ORDINANCE NO. 3373-14

**An Ordinance Amending the Development Agreement
for the Everett Riverfront District Properties
Related to the Simpson Site and Eclipse Mill Site, Amending Ordinance No. 3121-09**

**EXHIBIT 1
FIRST AMENDMENT
TO
DEVELOPMENT AGREEMENT**

Preliminary Development Plan – Revised Simpson and Eclipse Neighborhood Plans (Replaces pg. 1 of Attachment E to Dev. Agreement)

Pg. 29 (Lot width for single family – small lot)

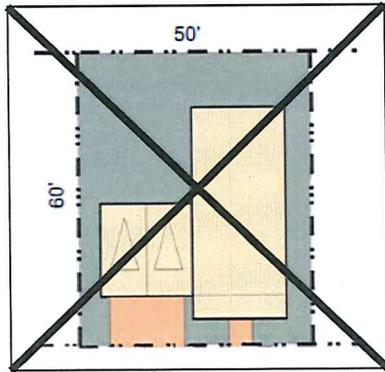
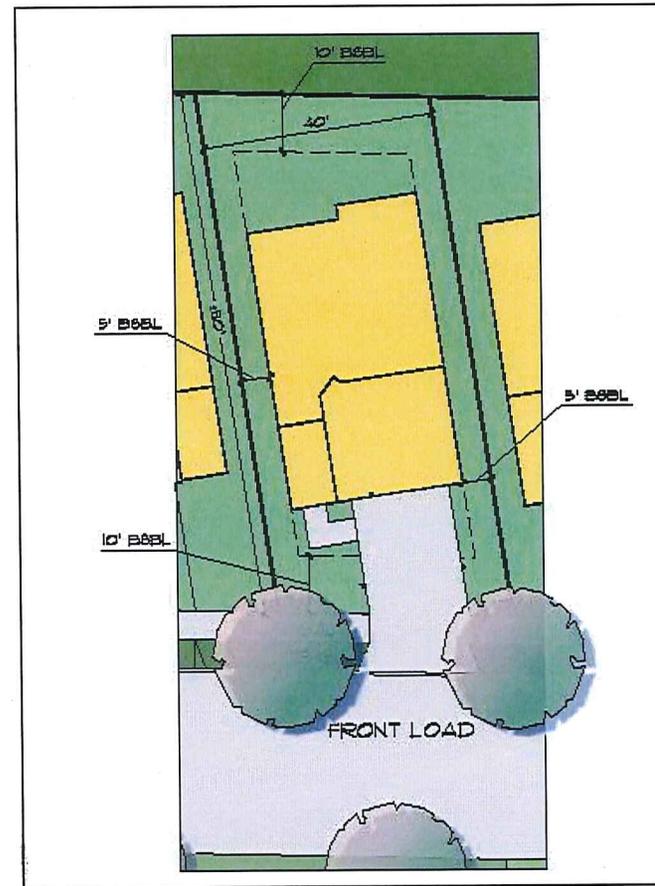
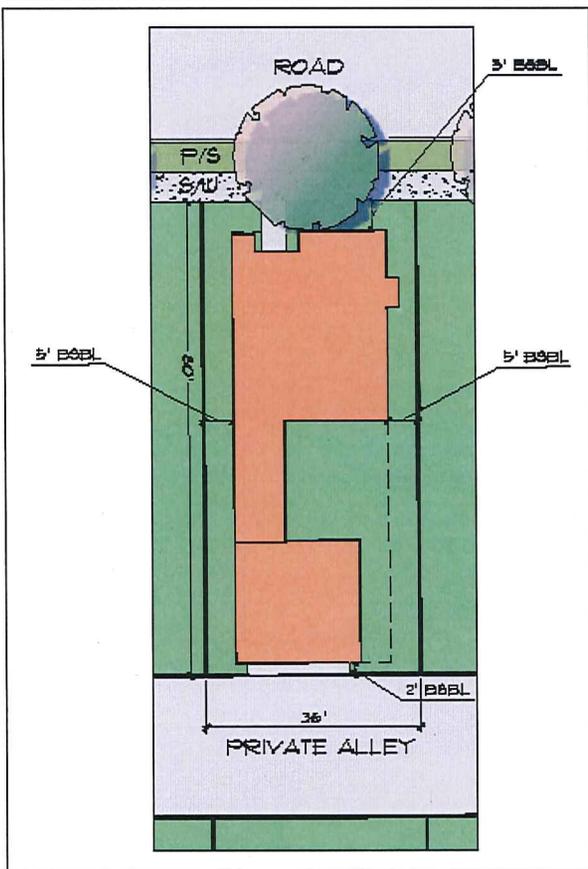
Delete graphic showing 50' lot width

Add graphics showing narrower front-loaded angled lots and an alley-loaded lot

Pg. 30 (Lanes)

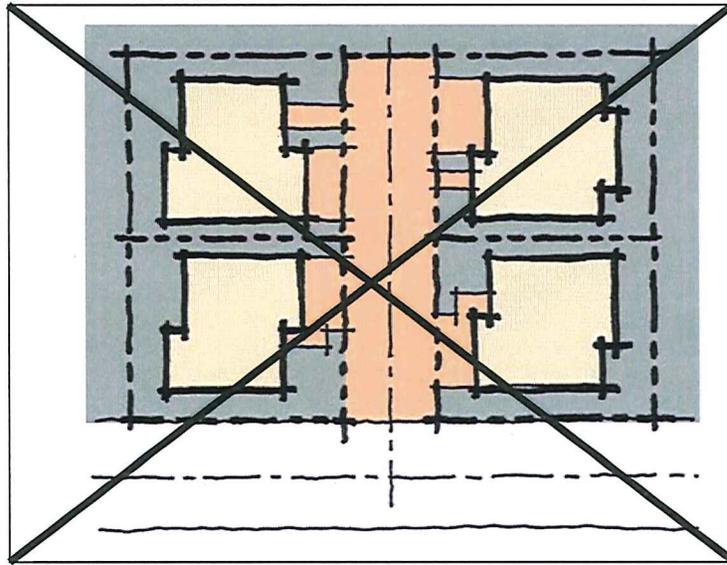
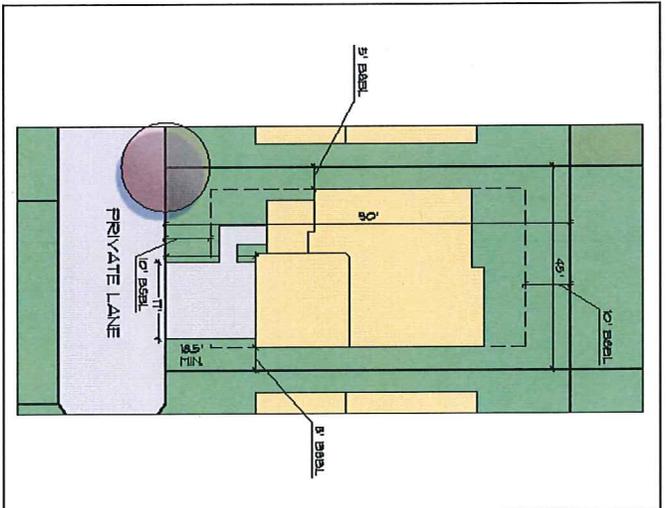
delete existing graphics

add new graphics

Pg. 33
(Townhouse)

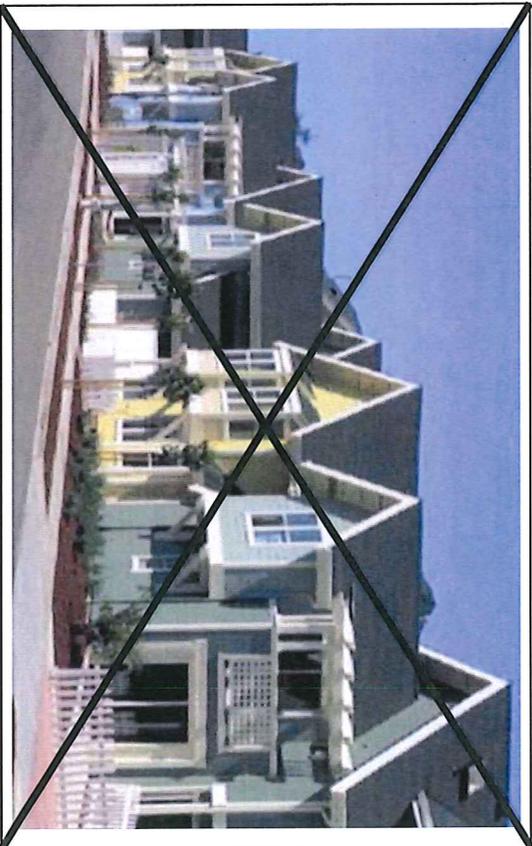
TOWNHOUSE (Private Alley Access)
single family dwelling units attached on one or more sides
Delete existing graphic

Add a new graphic
